UNITED STATES PATENT AND TRADEMARK OFFICE

APPLICATION NO.	FILING DATE	FIRST NAMED INVENTOR	ATTORNEY DOCKET NO.	CONFIRMATION NO.
10/037,325	01/03/2002	Harry W. Eberle III	(HWE-107A)	5841
7590 06/14/2004 KENNETH P. GLYNN, ESQ. Glynn & Associates, P.C. 24 Mine Street Flemington, NJ 08822			EXAMINER GARCIA, ERNESTO	
			ART UNIT 3679	PAPER NUMBER

DETAILED ACTION

5,704,181 (Fisher et al.)

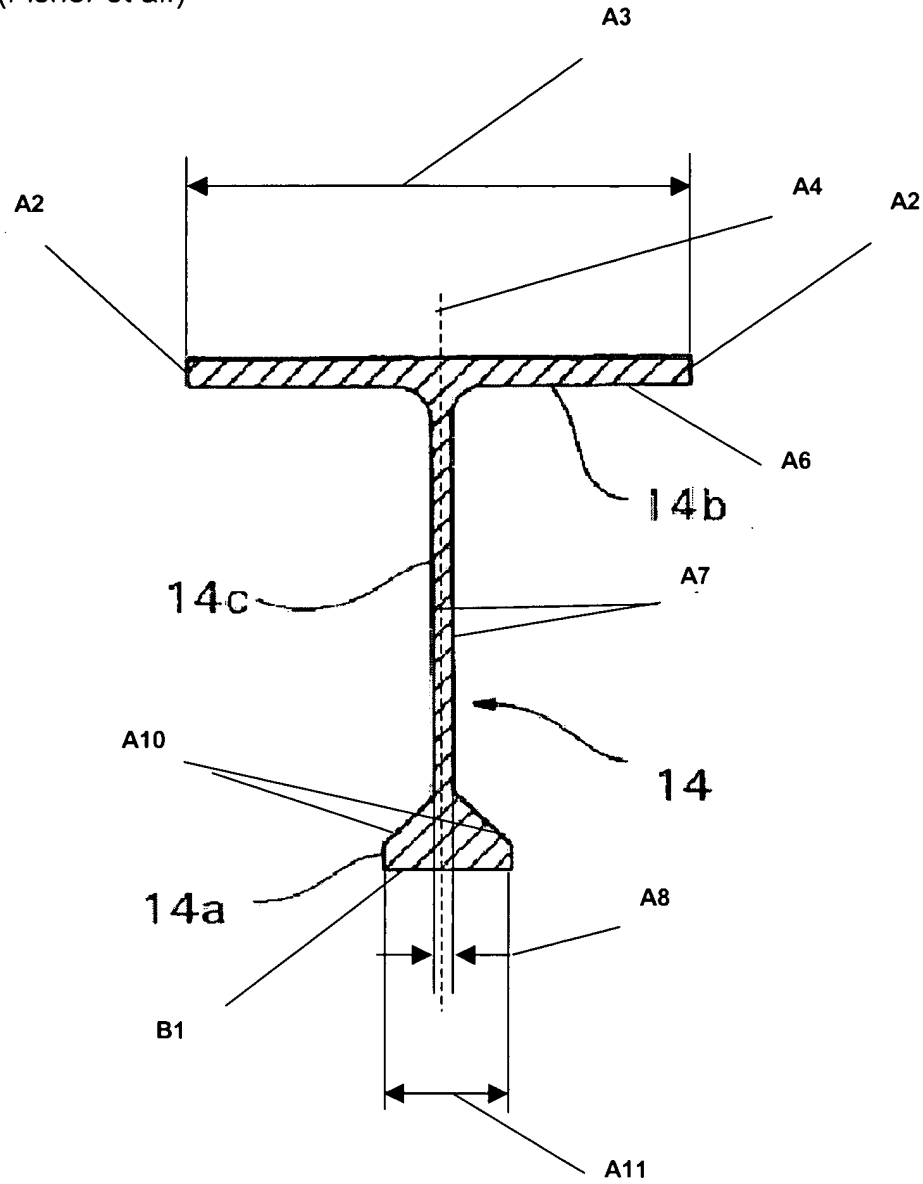
Claim 21 is rejected under 35 U.S.C. 102(b) as being anticipated by Fisher et al., 5,704,181 (see marked-up attachment).

Regarding claim 21, Fisher et al. disclose, in Figure 3, an anchoring device comprising a substantially flat horizontal top element **14b**, at least one substantially vertical support member **14c**, and a substantially flat horizontal bottom element **14a**.

The top element **14b** has a top view configuration including two sides **A2** and a predetermined first width **A3** as measured side to side. The first width **A3** is measured at a maximum width between the sides **A2**. The top element **14b** has an imaginary center line **A4**. The support member **14c** is attached to an underside **A6** of the top element **14b** along the center line **A4** and the support member **14c** extends downwardly therefrom. The support member **14c** has two sides **A7** and a predetermined second width **A8** as measured side to side at a maximum width. The bottom element **14a** has a flat bottom view configuration which includes sides **A10** and having a generally trapezoidal shape, and a predetermined third width **A11** as measured side to side at a maximum width at a trapezoidal base **B1**. The first width **A3** is greater than the second width **A8** and the third width **A11**. The third width **A11** is greater than the second width **A8**.

6,363,677 (Chen et al.)

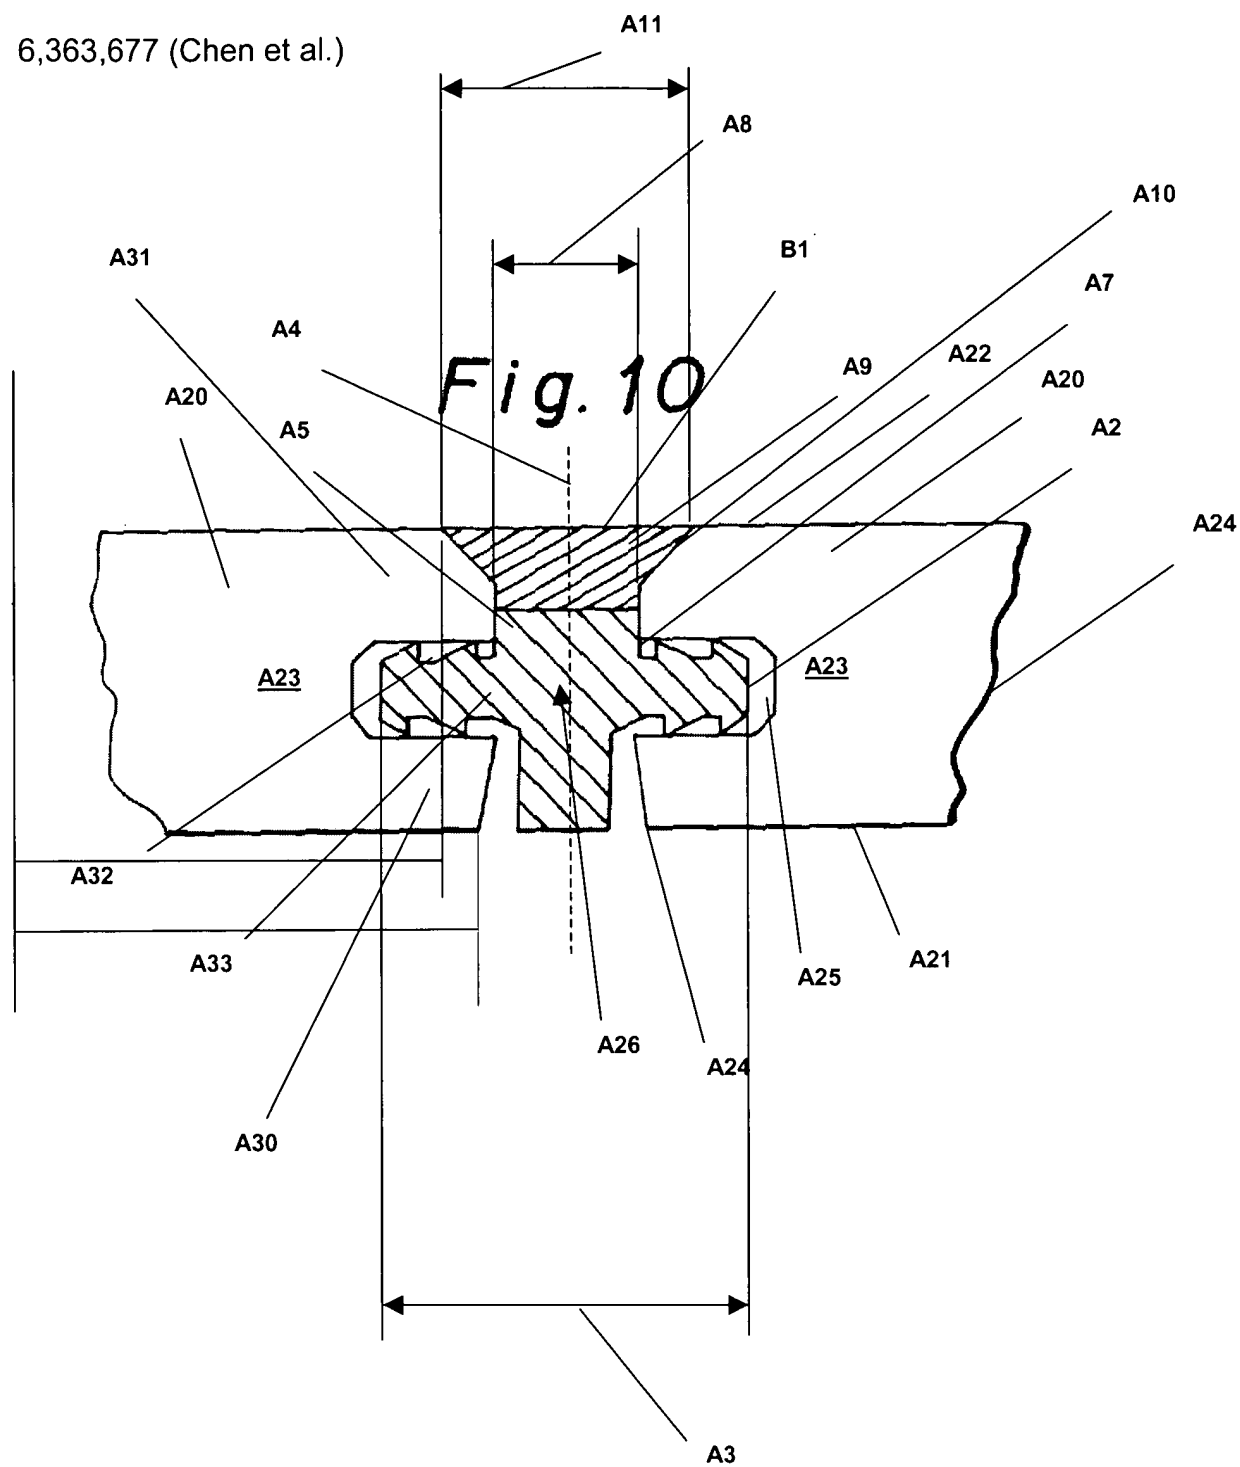
Claims 24 and 26-28 are rejected under 35 U.S.C. 102(e) as being anticipated by Chen et al., 6,363,677 (see marked-up attachment).

Regarding claim 24, Chen discloses in Figure 5, a decking system comprises boards **A20** and an anchoring device **A26**. Each of the boards **A20** has a top **A21**, a bottom **A22**, two sides **A23** and two ends **A24**. At least one groove **A25** is located along one of the sides **A23**. The device **A26** comprises a substantially flat horizontal top element **A1**, at least one substantially vertical support member **A5**, and a substantially flat horizontal bottom element **A9**. The top element **A1** has a top view configuration including two sides **A2** and a predetermined first width **A3** as measured side to side. The first width **A3** is measured at a maximum width between the sides **A2**. The top element **A1** has an imaginary center line **A4**. The support member **A5** is attached to an underside **A6** of the top element **A1** along the center line **A4** and the support member **A5** extends downwardly therefrom. The support member **A5** has two sides **A7** and a predetermined second width **A8** as measured side to side at a maximum width. The bottom element **A9** has a flat bottom view configuration which

includes sides **A10** and having a generally trapezoidal shape, and a predetermined third width **A11** as measured side to side at a maximum width at a trapezoidal base **B1**. The first width **A3** is greater than the second width **A8** and the third width **A11**. The third width **A11** is greater than the second width **A8**.

Regarding claim 27, the groove **A25** establishes an upper half **A30** of each of the boards **A20** above the groove **A25** and a lower half **A31** of each of the boards **A20** below the groove **A25**. The upper half **A30** has a greater width than the lower half **A31**. Compare widths **A32** and **A33**.
